Subject: Docket No. 50-206
Masonry Wall Test Program
SEP Topic III-6
Seismic Design Considerations
San Onofre Nuclear Generating Station
Unit 1

RESPONSE TO NRC STAFF CONCERNS ON
MASONRY WALL TEST PROGRAM
NOVEMBER 1982

SAN ONOFRE NUCLEAR GENERATING STATION
UNIT 1

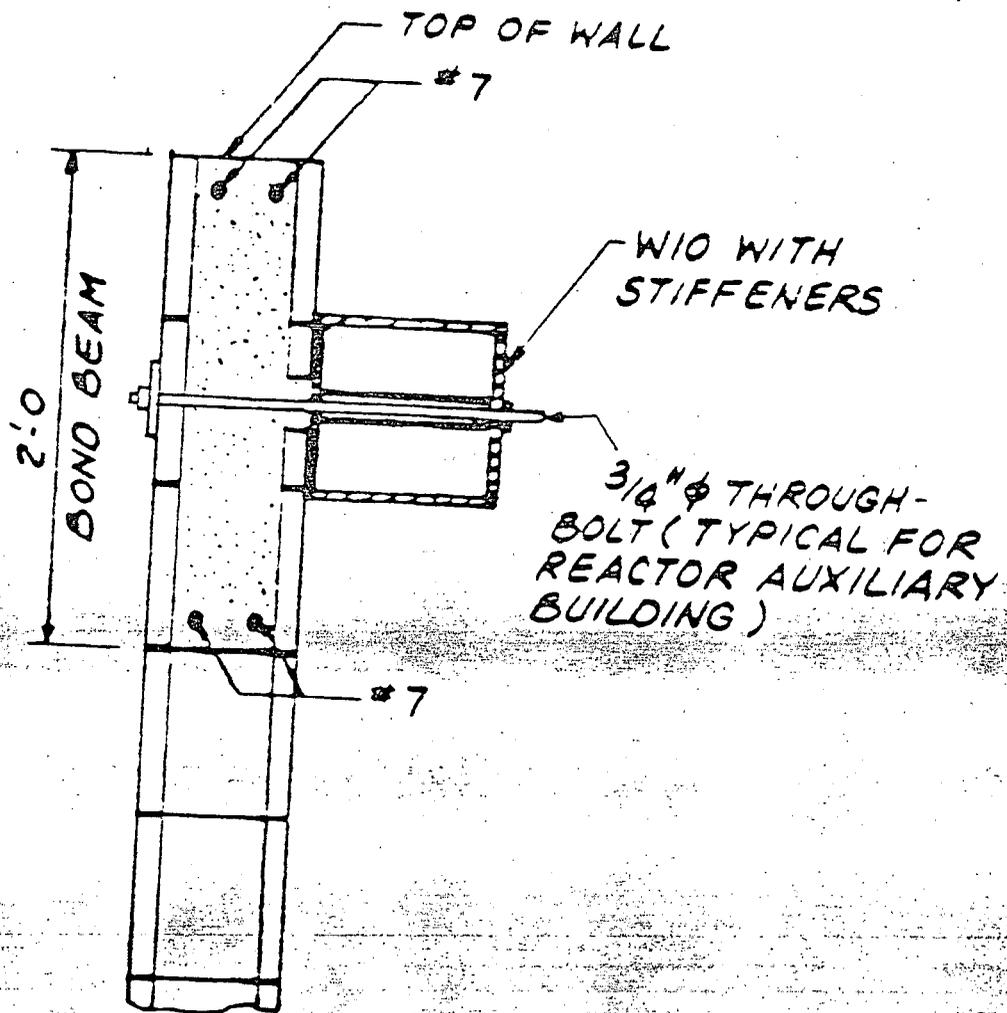
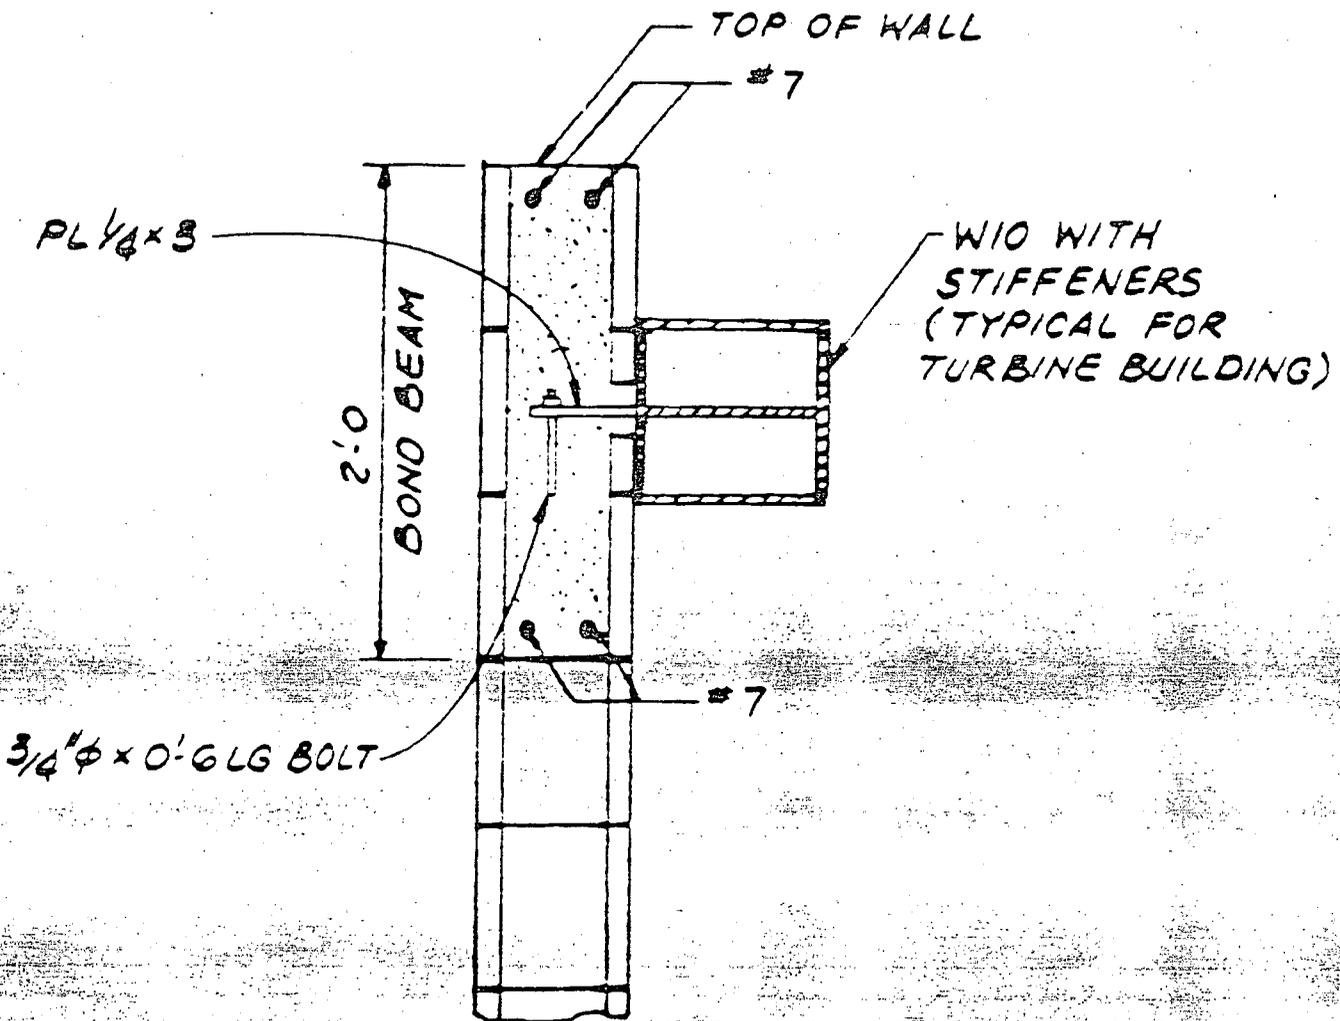
Describe how the closeness/similarity between the test walls and the insitu walls are to be assured with respect to the construction material and boundary conditions.

All of the walls considered applicable for the nonlinear analysis are dowelled into concrete members (footings, slabs, etc.) at their base. The base detail for each of the test panels will also be dowelled into a concrete base, utilizing the same area of dowelled steel and the same embedment percentage as in the insitu walls. This assures the same boundary conditions at the base of the test panels as are present in the insitu walls. All of the walls considered applicable for the nonlinear analysis have a pin connection at their tops. This connection is typically a ledger angle or in the case of the Turbine Building (Panel Type 3) a plate. The test panels will all have connections at the top of the wall similar to that shown in Figures 4.1 through 4.3. The top actuator will be attached to the steel member at the top of the panel via a pin connection. Therefore, the top connection of the test panels will be a pin, just as in the insitu walls.

CONTROL CONDUIT SUPPORT
FOR PANEL TYPE 3
ELEVATION VIEW
FIGURE 5.1

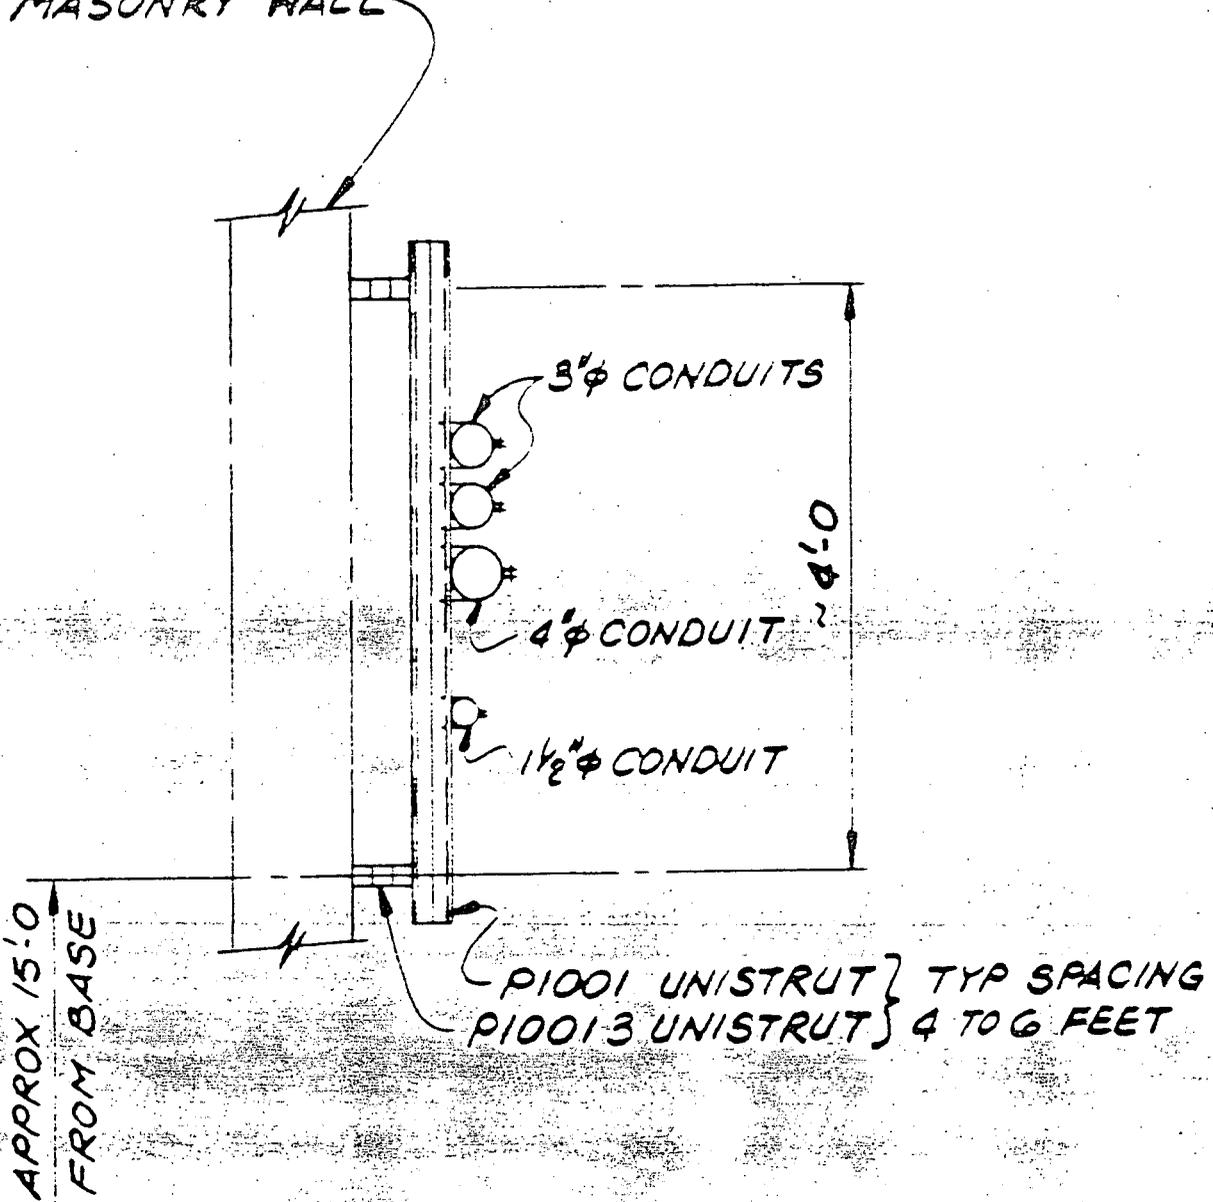
Give detailed discussion about and justification for major piping/equipment attachment simulation in terms of weights, eccentricities and locations of such attachments. Also discuss the methods in attaching these piping/equipment.

The twenty-one foot high walls of the Turbine Building (represented by Panel Type 3) do have a significant amount of attached electrical conduit in many areas. Figure 5.1 shows a particular support which occurs on a Turbine Building wall. This support is typical of those supports with the greatest weight and highest eccentricity for these walls. The weight carried by this support is estimated to be 250 pounds and the eccentricity is ten inches. The support is located at the extreme top of the wall. The great majority of the electrical conduit supports on these walls support horizontal conduit runs and occur within the top or bottom third of the wall. For testing purposes it is intended to represent four or five of these supports or similar supports within the top and/or bottom third of the wall. The supports and weights associated with them will be configured and placed in such a manner as not to interfere with the testing instrumentation on the test panel. It should be noted that for simplicity, during the analysis it was assumed that all conduits were filled to capacity. This is not the case in reality and the information concerning weights contained in this response is based on information gathered during the current raceway support seismic reevaluation program.

TOTAL WEIGHT TO
SUPPORT 250 LBS
BASED ON 70% FILL
AND 5 FOOT TRIBUTARY
LENGTH
